FERN CREEK TOWNS TOWNHOME PD

SUMMARY

Zoning - Proposed ZON2016-00019

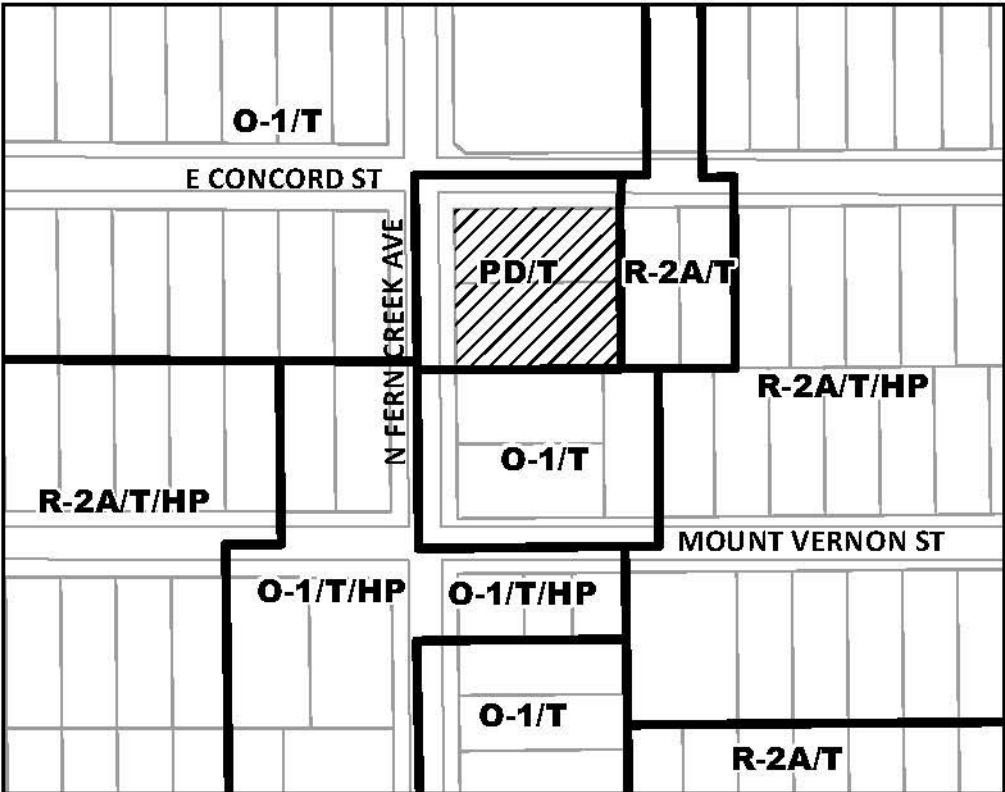
The site is zoned O-1/T (Office/Traditional City overlay) and has a Future Land Use designation of Office Low. A rezoning to PD/T (Planned Development/Traditional City overlay) is proposed. The proposal is consistent with the existing Future Land Use and Zoning designations.

Proposed Curbcut

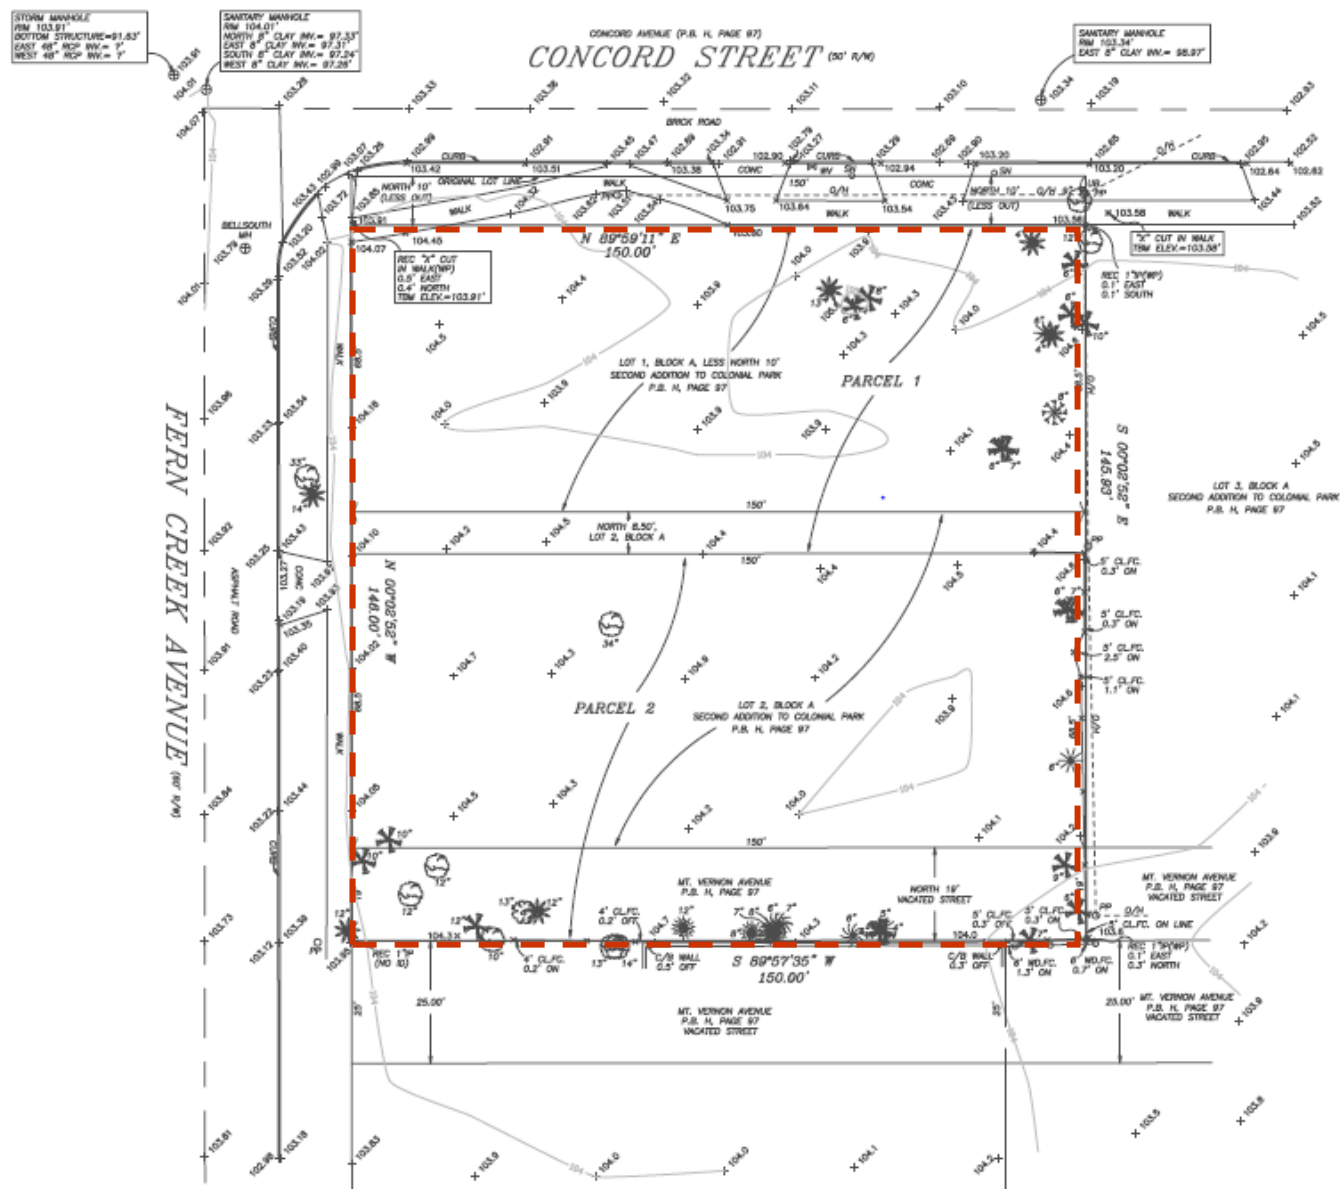
1. Driveway Location. The driveway must be located on Concord St to minimize the number of driveway conflicts on Fern Creek Ave. This would also provide a safer entry and exit point for future residents as Fern Creek Ave carries a higher volume of vehicles at speeds that are higher than what is found on a local road like Concord St.
2. Parking Lane. A minimum 9' wide parking lane must be constructed along Fern Creek Ave to provide additional public parking. This parking must be offset from the intersection according to FDOT Index 17346. The sidewalk adjacent to this parking lane must be widened to 6' and must be adjacent to the back-of-curb.
3. Curbcut Removal. All unused or abandoned curbcuts / driveways shall be removed and all curbs, gutters, parkways and side-
